Part 21 (PAR)

Event # 52762

NOTIFICATION UNDER 10 CFR PART 21 OF BETTIS BRAND SEISMIC QUALIFIED G SERIES SPRING RETURN ACTUATORS

Re: Notification under 10 CFR Part 21 of Bettis Brand Seismic Qualified G Series Spring Return Actuators

FIGURE A

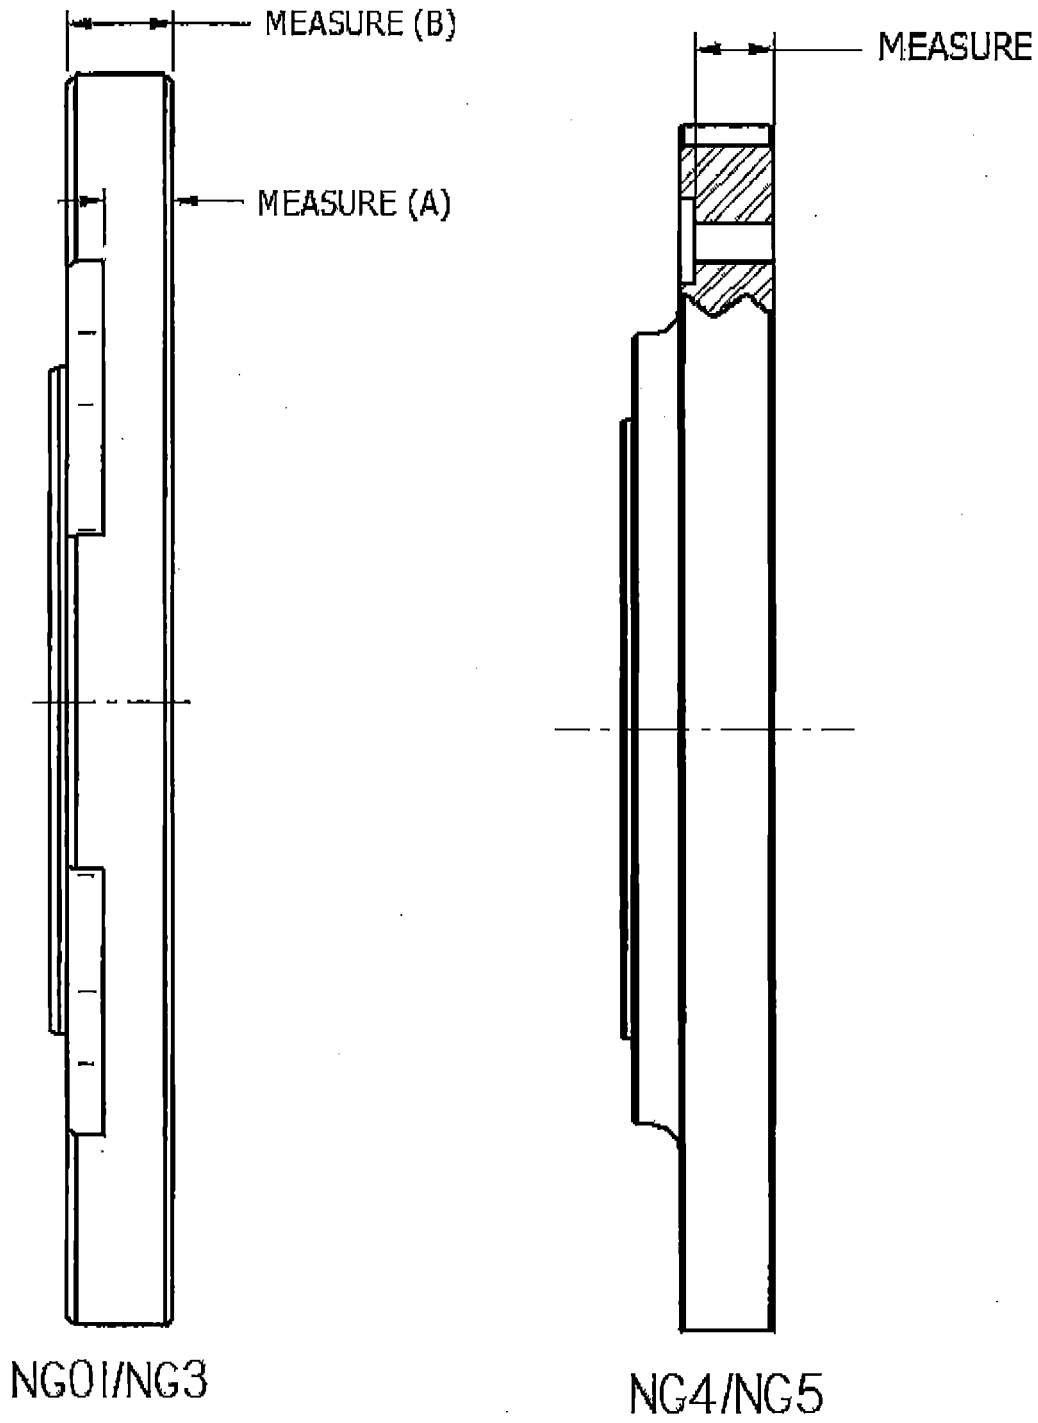
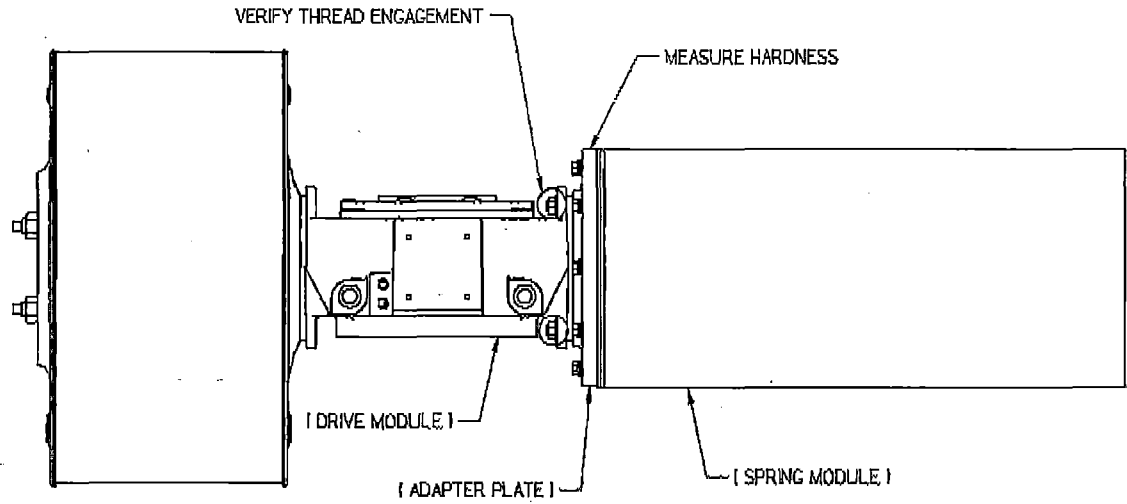
Certain measurements should be taken to remedy the inspection nonconformance. All measurements may be taken in situ with the actuator assembled to the valve. Please refer to Figure A (attached) depicting the feature to be measured. The numbered measurements in Figure A correspond to the numbered measurement inspection procedure below. Table 1 provides measurement values for reference. Remedial inspection recommendations are to:

1. Confirm the thickness of the plate at the point where the bolt head & washer engage the flange surface. This location may be a milled flat section or counter sunk hole depending on the actuator size.
2. Verify full thread engagement for nuts installed on bolts for the housing flange.
3. Perform hardness testing on a small area on the outside diameter of the adaptor plate. The paint will need to be removed at the point of hardness testing.

Should the adaptor plate fail to meet the above specifications, please contact us promptly.
